PARTS & SERVICE NEWS

REF NO.	AT01222
DATE	Dec. 25, 2001

SUBJECT: REPAIR OF CRACK AND REINFORCEMENT ON EXTERIOR ON WA1200-3

PURPOSE: To introduce modification procedures to repair cracks of the external parts and to reinforce their structures on the WA1200-3 wheel loaders

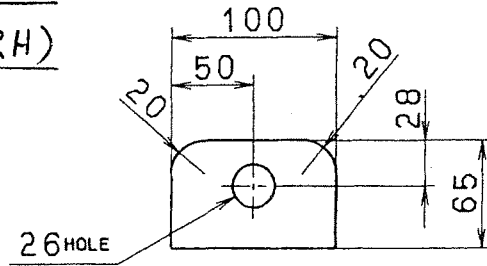
- (1) Make the modification in the sections indicated in the drawing below.
Be sure to paint after the rework.

(2) Dimensions of the reinforcement plate for the engine hood mount bracket and details of the repairing procedure (The LH side bracket and the RH side bracket are symmetrical.)

(New parts)

42C-54-11215 (LH)

42C-54-11225 (RH)

(Current parts)

42C-54-11214

42C-54-11224

The part numbers of the bracket have been changed as above.

② Material : SS400P t 6
Qty : 4 pcs./unit

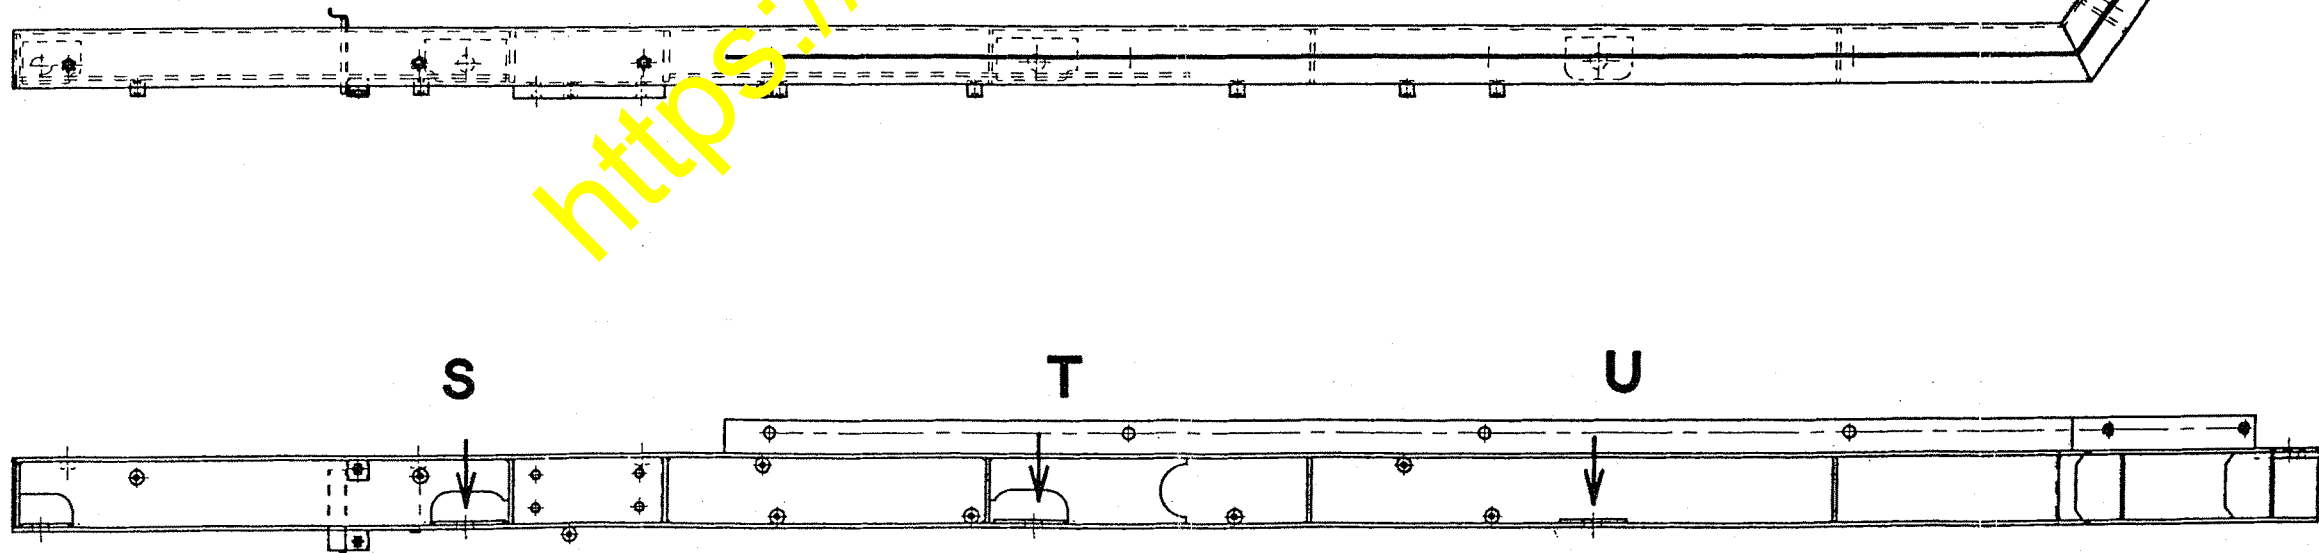
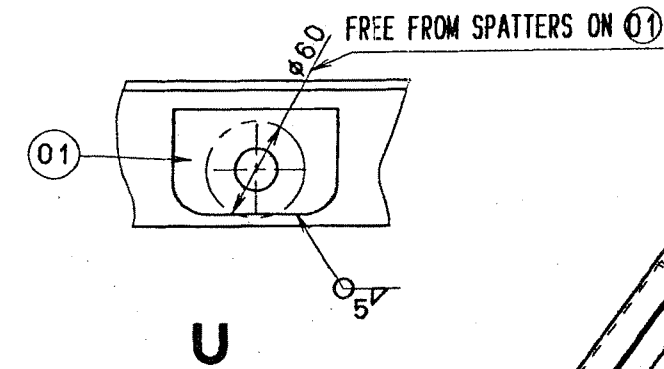
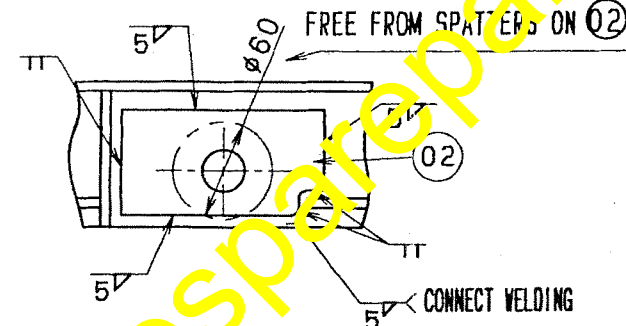
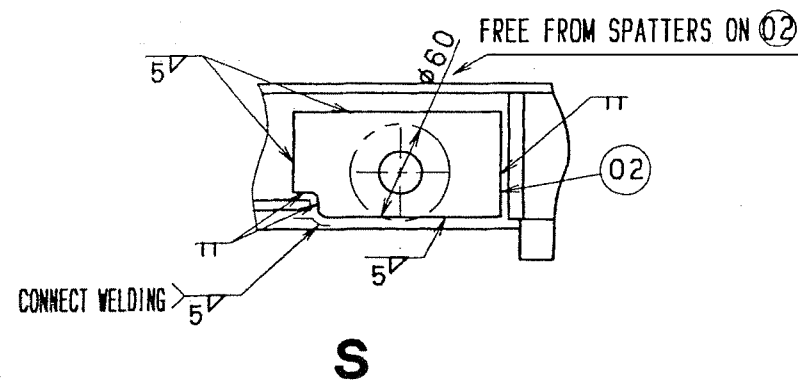
The bolts being used for the sections "S", "T" and "U" are to be changed from 01011-82010 to 01011-82015.
